CONTRACT: D13POC.BM.31161 BRIDGE PROJECT: 18313.1011215.PR

LOCATION: REPAIR BRIDGE #100734 ON OLD MARS HILL HWY  
OVER IVY CREEK

TYPE OF WORK: STRUCTURE REPAIR

STATE OF NORTH CAROLINA DEPARTMENT OF TRANSPORTATION RALEIGH						SHZET NO.
<b>GENERAL DRAWING</b>						<b>2</b>
FOR BRIDGE ON SR 2207 OVER BIG IVY CREEK BETWEEN SR 2148 AND SR 2150						TOTAL SHEETS
REVISIONS						
NO.	BY	DATE	NO.	BY	DATE	
1			3			
2			4

**FRAMING PLAN**

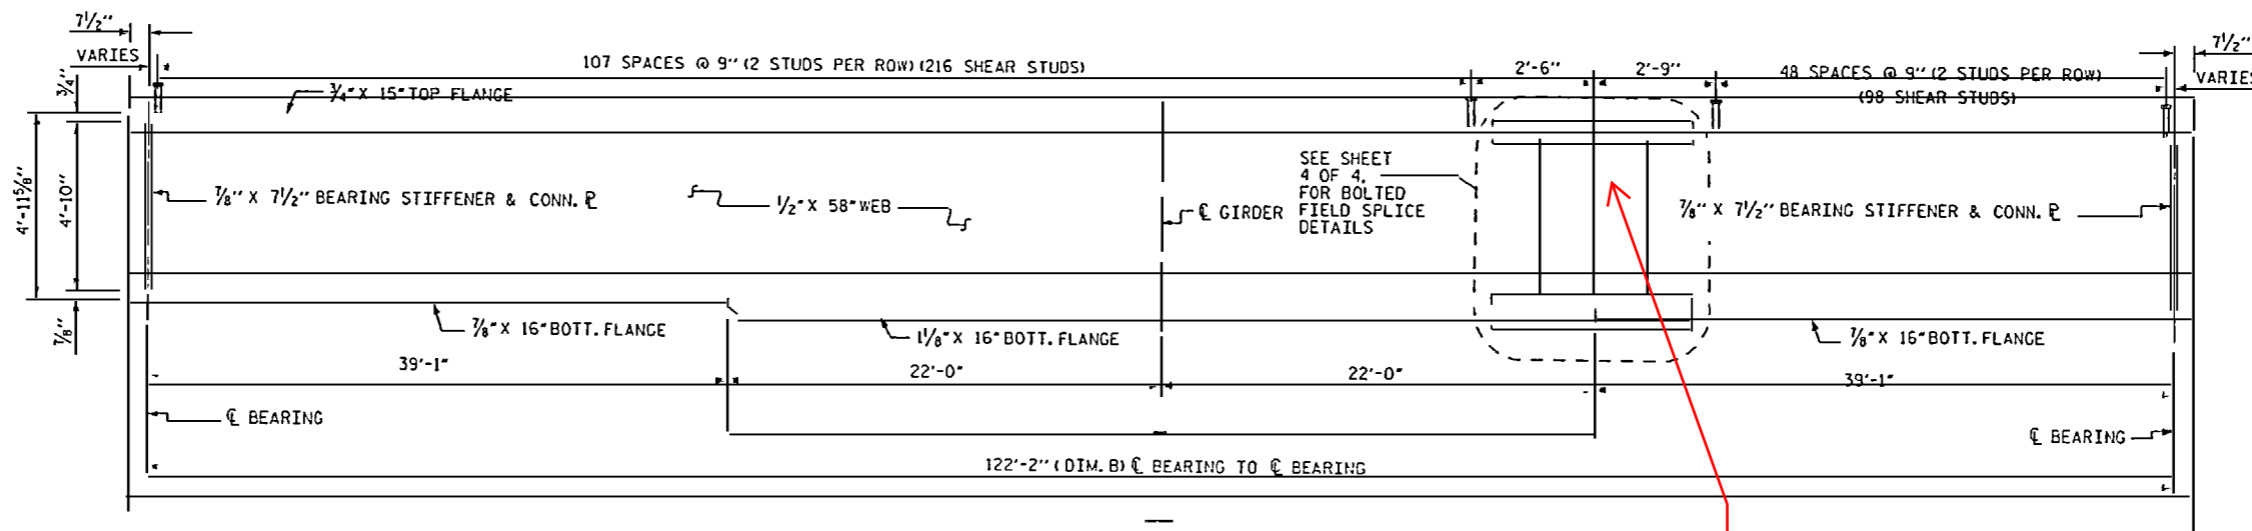
1: LOWER PORTION OF WEB DISTORTED ALONG LONGITUDINAL AXIS UP TO \_\_\_ " MAX.

2: WEB DISTORTED ABOUT VERTICAL AXIS \_\_\_ TOWARD LEFT AND RIGHT AT VERTICAL WELD SPLICE LOCATION

3: UP TO 1/2" WEB DISTORTION ABOUT VERTICAL AXIS TOWARD UPSTREAM AND DOWNSTREAM (TYP. BETWEEN ALL INT. DIAPHRAGMS)

4: ALL INT. DIAPHRAGMS IN BAY 3 HAVE BUCKLED W/ DISTORTION IN WEB STIFFENER PLATES AT BOLTED CONN'S.

**TYPICAL INTERMEDIATE CROSSFRAME (CF2)**

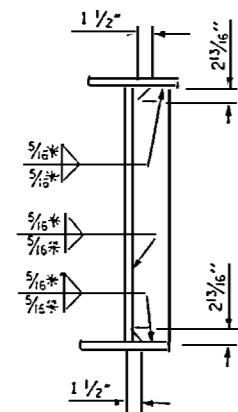
CONNECTOR PLATES BUCKLED

4 CROSSFRAMES IN BAY 3 TO BE REPLACED. REPLACEMENT OF DIAPHRAGMS IN BAY 1 AND 2 MAY BE REQUIRED AT THE DIRECTION OF THE ENGINEER.

**PLAN OF PARAPET AND RAIL POST SPACINGS**

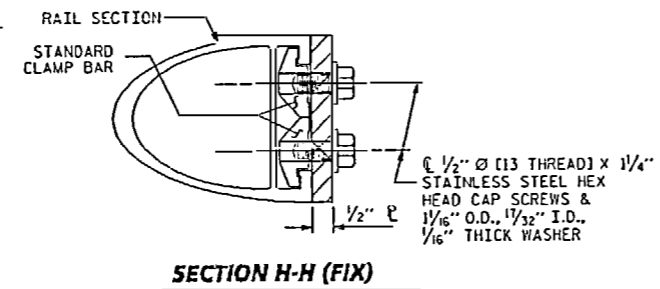
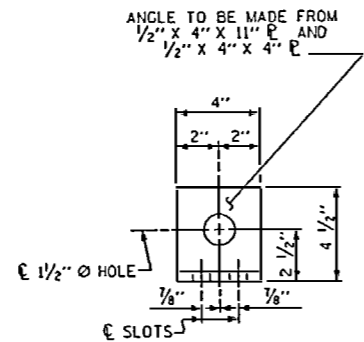
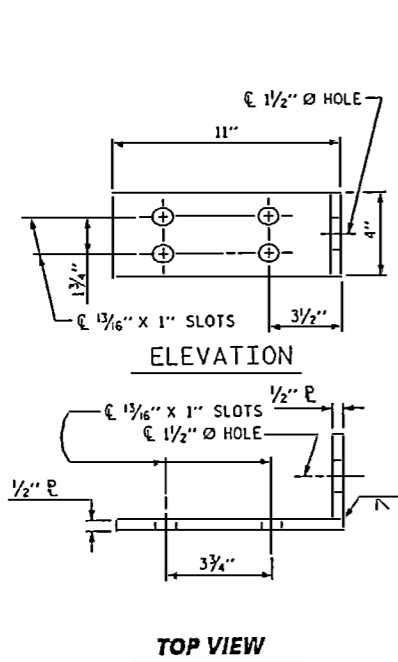
2) Broken welds on 8 railing posts on the upstream end
